The Commission has issued the enclosed Amendment No. 104 to Facility Operating License No. DPR-31 and Amendment No. 98 to Facility Operating License No. DPR-41 for the Turkey Point Plant Units Nos. 3 and 4, respectively. The amendments consist of changes to the Technical Specifications in response to your application transmitted by letter dated August 6, 1982, as modified on September 1, 1982, January 3, 1983, April 25, 1983, January 31, 1984 and April 23, 1984.

These amendments provide requirements in the Technical Specifications for protection of safety-related equipment subjected to sustained degraded voltage conditions at the offsite power source and interaction between the offsite and onsite source.

SAFETY EVALUATION BY THE OFFICE OF NUCLEAR REACTOR REGULATION
RELATED TO AMENDMENT NO. 104 TO FACILITY OPERATING LICENSE NO. DPR-31
AND AMENDMENT NO. 98 TO FACILITY OPERATING LICENSE NO. DPR-41

TECHNICAL EVALUATION REPORT (REVISION 1)
ON THE PROPOSED DESIGN MODIFICATIONS AND
TECHNICAL SPECIFICATION CHANGES ON
GRID VOLTAGE DEGRADATION FOR THE
TURKEY POINT NUCLEAR GENERATING PLANT
UNITS 3 AND 4

FIGURE 1 TURKEY POINT UNITS 3 AND 4 ELECTRICAL ONE-LINE DIAGRAM

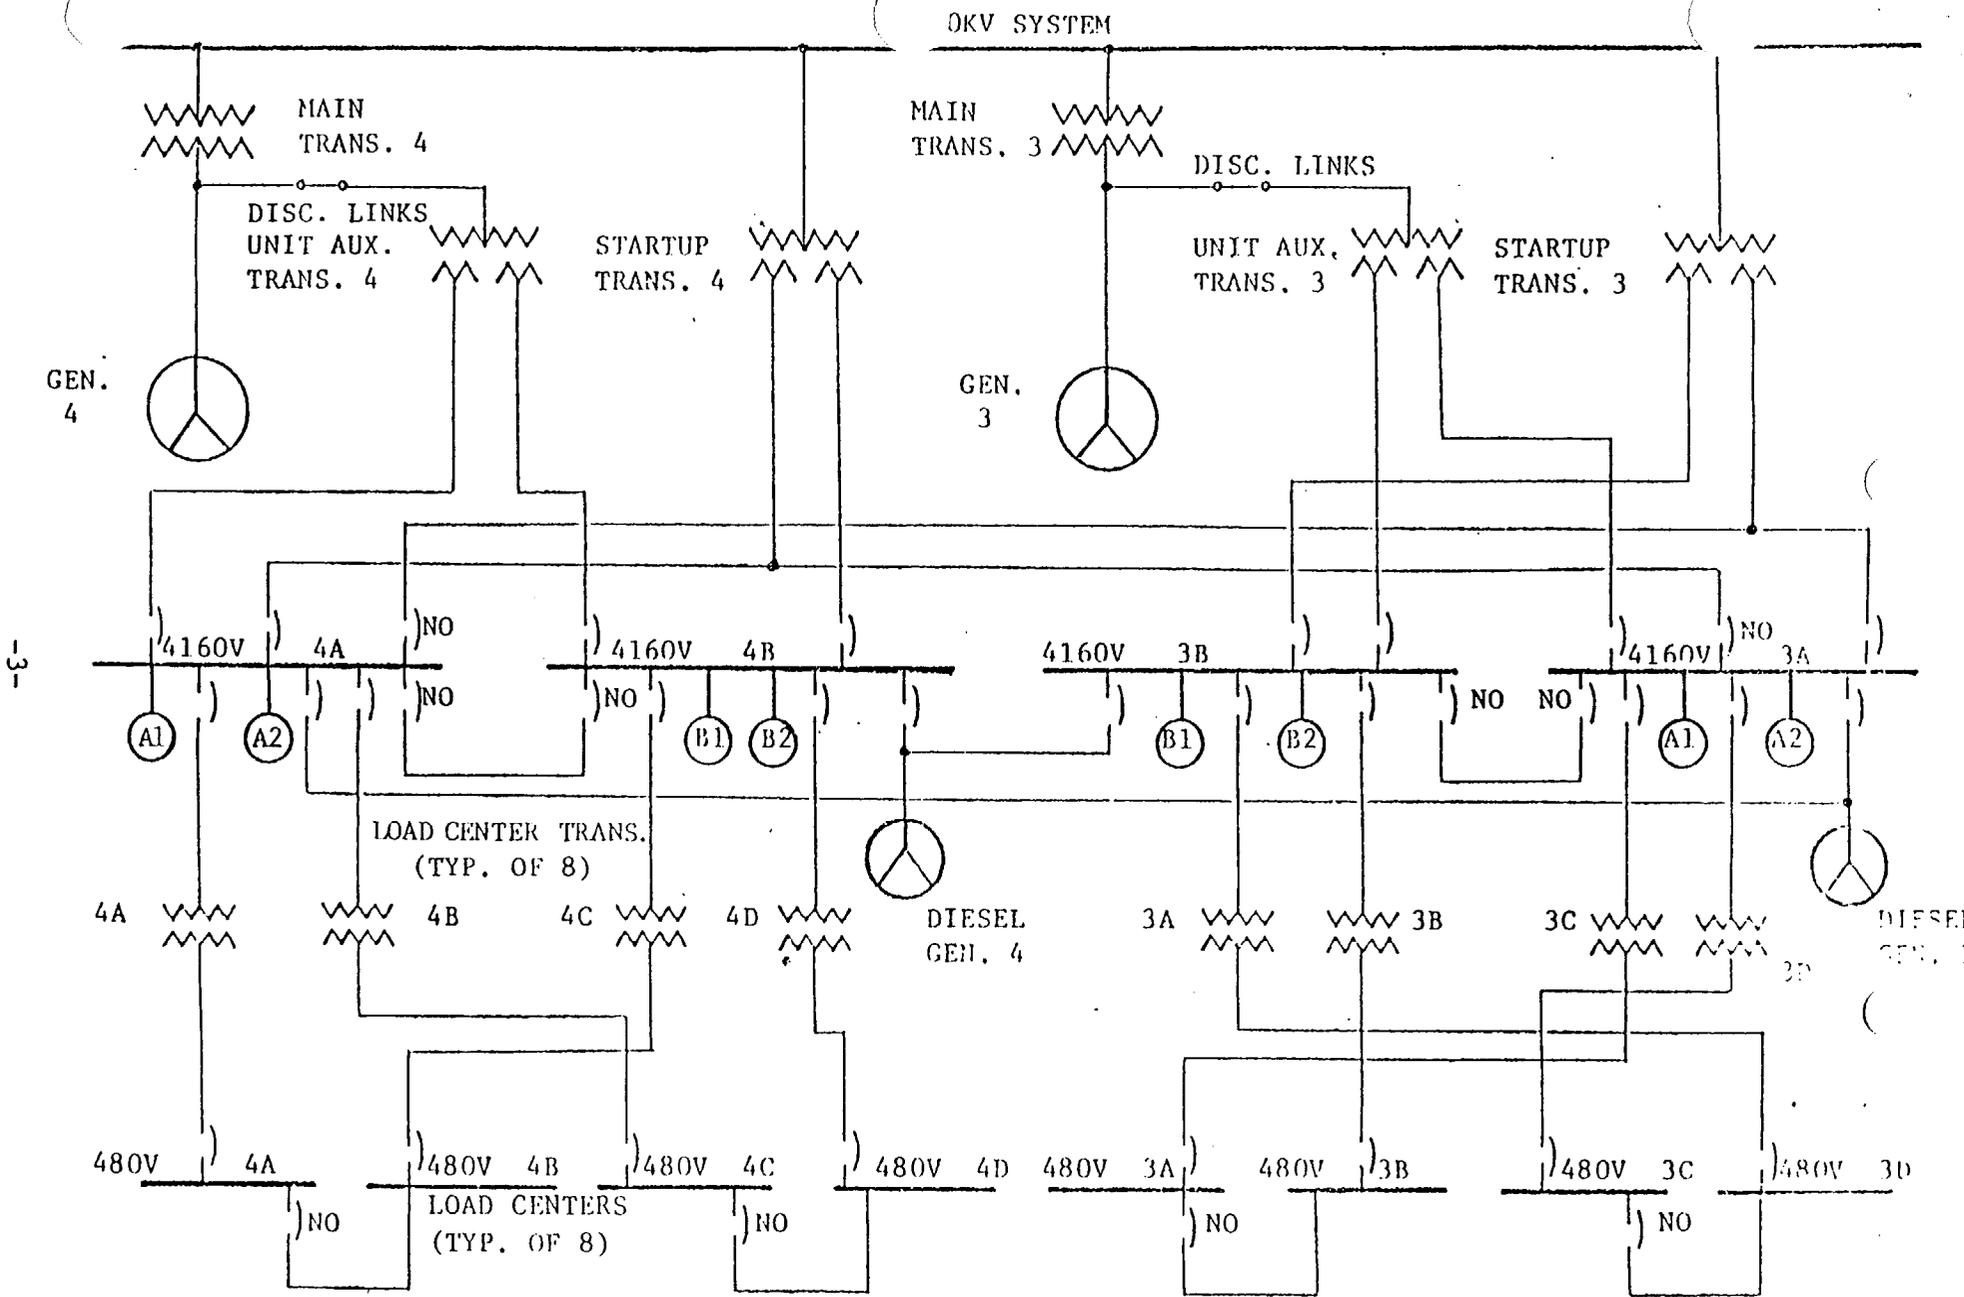
The present undervoltage protection design utilizes two undervoltage relays on each of the 4160-volt Class 1E buses (Buses A and B of Figure 1). The relays are instantaneous type HGA which respond at 40% - 50% of 4160 volts. These relays are used as loss-of-voltage protection.

The relay logic (2-out-of-2) is such that actuation of one relay (A1 or A2) on "A" bus in conjunction with the actuation of its interconnected relay (B1 or B2) on "B" bus will initiate the offsite source disconnection, load shedding, diesel generator starting and subsequent load sequencing on both buses. For example, the starting of diesel generator 3 and the disconnection of startup transformer 3 is initiated by the actuation of relay A1 on bus 3A and relay B2 on bus 3B or the actuation of relay A1 and the starting sequence of diesel generator 4. This logic scheme results in two separate and redundant circuits.

The load shedding feature is not bypassed when the Class 1E buses are being supplied by the diesel generators.

- (1) The logic of the existing relays will be reconnected such that the offsite source disconnection, load shedding, diesel generator starting, and load sequencing will occur only for that bus on which the loss of voltage occurs. The logic will remain 2-out-of-2 but the scheme on bus A will now be independent of that on bus B.

- (2) The installation of two additional instantaneous relays (type ITE27H) with a definite-time delay and two inverse-time relays (type IAV) with a definite-time delay on each 480-volt Class 1E load center. Both sets of relays will be in a 2-out-of-2 coincident logic scheme. The instantaneous relays will protect the Class 1E equipment at both the 4 kV and 480-volt levels from sustained degraded voltages under accident conditions. The inverse-time relays will also protect the Class 1E equipment at both voltage levels under non-accident conditions. Actuation of either set of relays will initiate the tripping of the incoming 4 kV feeder breakers, diesel generator starting, load shedding, and subsequent load sequencing. Both sets of the relays (instantaneous and inverse time) are also interlocked with the 'b' contact of diesel generator breaker to disable the load-shedding feature when the diesel generators are on line and to reinstate the feature following breaker tripping.

The operation of the IAV relays on the 480-volt Class 1E load centers, in a 2-out-of-2 coincident logic, will automatically initiate the disconnection from the offsite source whenever the voltage and time delay setpoints are exceeded. The operating time of the IAV relay is such that as the rate of voltage degradation increases, the associated time delay becomes shorter. Should a degraded voltage occur concurrent with a safety injection signal, the relays (ITE 27H) located on the 480-volt Class 1E load center buses, in a 2-out-of-2 coincident logic, will initiate the auto-disconnection from the degraded offsite source after a definite-time delay (10 seconds).
